DOCKET ITEM #11

Text Amendment #2015-0003

**Coordinated Development District Concept Plan #2015-0003
430 & 450 South Pickett Street – Cameron Park**

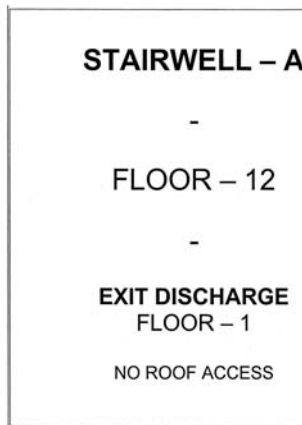
- Turning Radius – Wall to Wall = 54.98 feet + / - 2 feet
Curb to Curb = 51.33 feet + / - 2 feet
Inside turning radius = 37.73 feet + / - 2 feet
- Overall Length – 47' – 4 ½"
- Overall Width – 98"
- Wheel Bases from front axle to both rear axles – 240"
- Tandem axle spacing – 56" CL of axle to CL of axle
- Gross Weight – As built with no equipment or water gross weight = 66,000#
- Angle of Approach – 13 Degrees
- Angle of Departure – 11 degrees

- Ramp Break Over – Break over angle is 9°

Applicant has provided requested information. However, the turning radius demonstrated on the plans is too tight and will cause access problems for the fire department.

Figure 1020.1.6.2 Example Building Footprint Sign

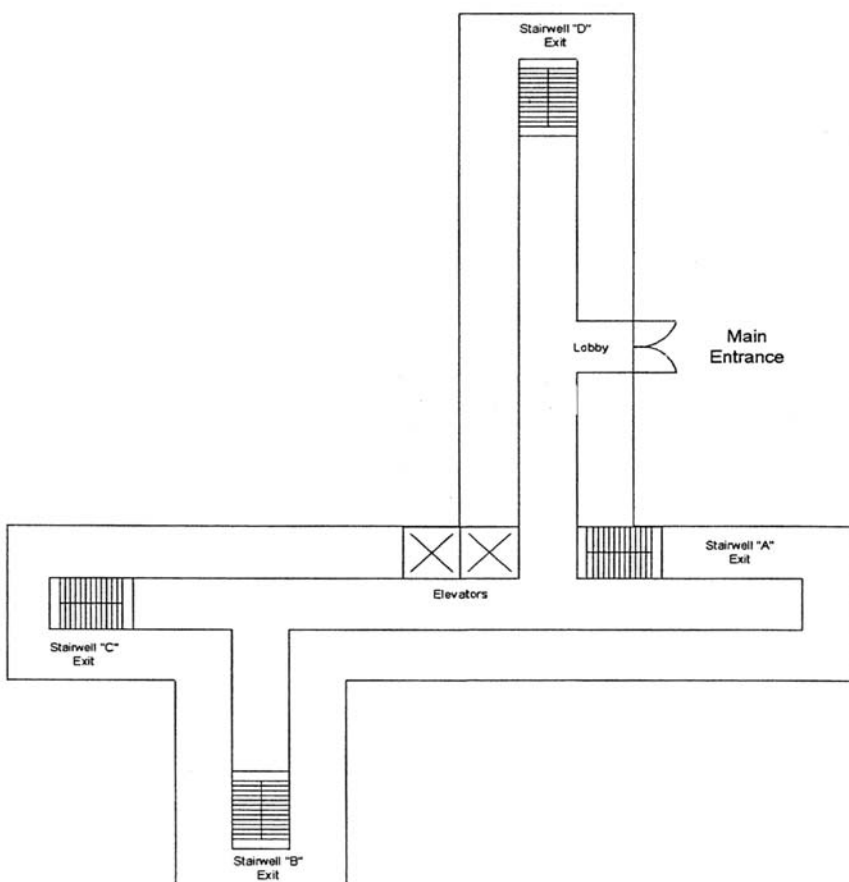
- C -10 Provide Stairway Identification. A sign shall be provided at each floor landing in interior vertical exit enclosures connecting more than three stories designating the floor level, the terminus of the top and bottom of the stair enclosure and the identification of the stair. The signage shall also state the story of, and the direction to the exit discharge and the availability of roof access from the stairway for the fire Department, in accordance with USBC 1020.1.6.

Footprint requirements. In buildings greater than three stories where there is no graphic representation of the building footprint, a simplified building schematic must be display in the lobby. The simplified building footprint shall be an overhead view of the buildings exterior and the general layout of the lobby of the first floor. Stairways shall be denoted by letter as stated in section 1020.1.6. (See Figure 1020.1.6.2)

Previously acknowledged by applicant.

Emergency Vehicle Easements

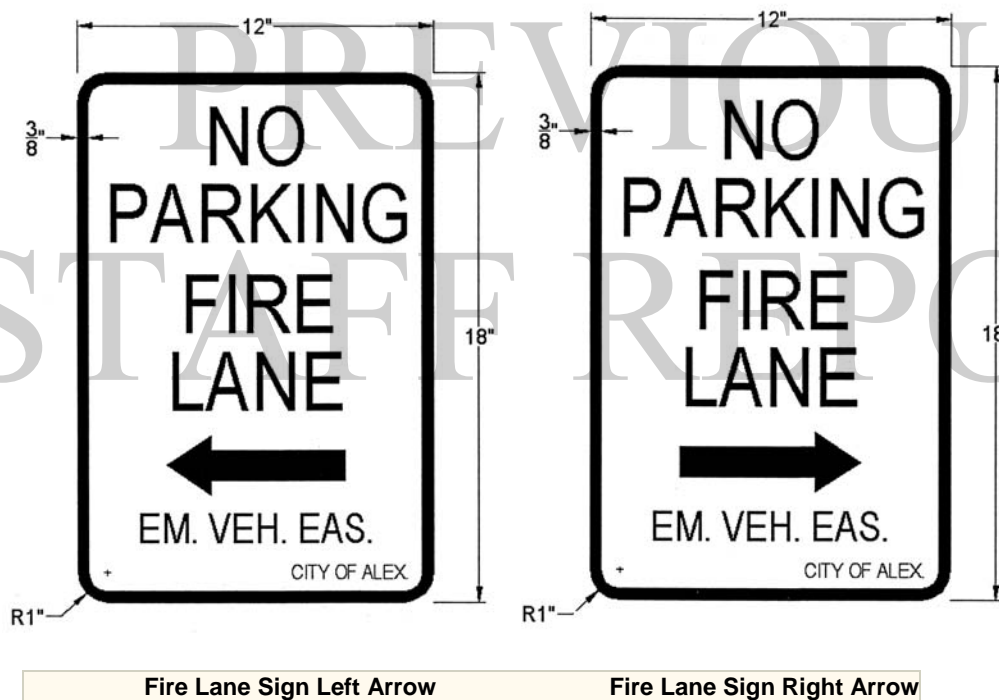
- C-8 The final site plans shall show placement of emergency vehicle easement signs. See sign detail and placement requirements below.

Emergency Vehicle Easements. Emergency vehicle easements shall be a minimum of 22 feet across the travel lane. The emergency vehicle easement shall provide access to strategic areas of the building and fire protection systems. Curbing and street components shall conform to the standards established by Transportation and Environmental Services and this document for emergency vehicle easements.

Tower 203 Turning Specifications

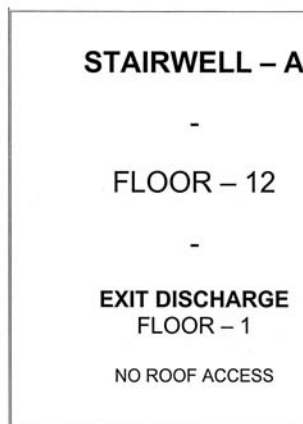
- Turning Radius – Wall to Wall = 54.98 feet + / - 2 feet
Curb to Curb = 51.33 feet + / - 2 feet
Inside turning radius = 37.73 feet + / - 2 feet
- Overall Length – 47' – 4 ½"
- Overall Width – 98"
- Wheel Bases from front axle to both rear axles – 240"
- Tandem axle spacing – 56" CL of axle to CL of axle
- Gross Weight – As built with no equipment or water gross weight = 66,000#
- Angle of Approach – 13 Degrees
- Angle of Departure – 11 degrees
- Ramp Break Over – Break over angle is 9°

Applicant has provided requested information. However, the turning radius demonstrated on the plans is too tight and will cause access problems for the fire department.

Figure 1020.1.6.2 Example Building Footprint Sign

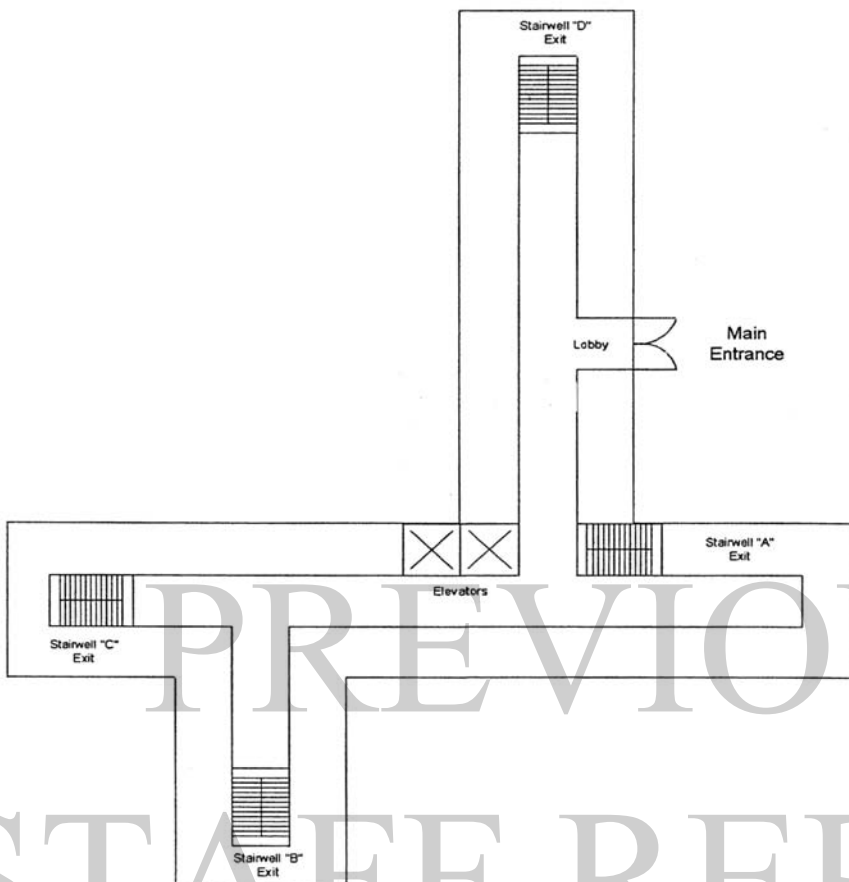
- C -10 Provide Stairway Identification. A sign shall be provided at each floor landing in interior vertical exit enclosures connecting more than three stories designating the floor level, the terminus of the top and bottom of the stair enclosure and the identification of the stair. The signage shall also state the story of, and the direction to the exit discharge and the availability of roof access from the stairway for the fire Department, in accordance with USBC 1020.1.6.

Footprint requirements. In buildings greater than three stories where there is no graphic representation of the building footprint, a simplified building schematic must be display in the lobby. The simplified building footprint shall be an overhead view of the buildings exterior and the general layout of the lobby of the first floor. Stairways shall be denoted by letter as stated in section 1020.1.6. (See Figure 1020.1.6.2)

Previously acknowledged by applicant.
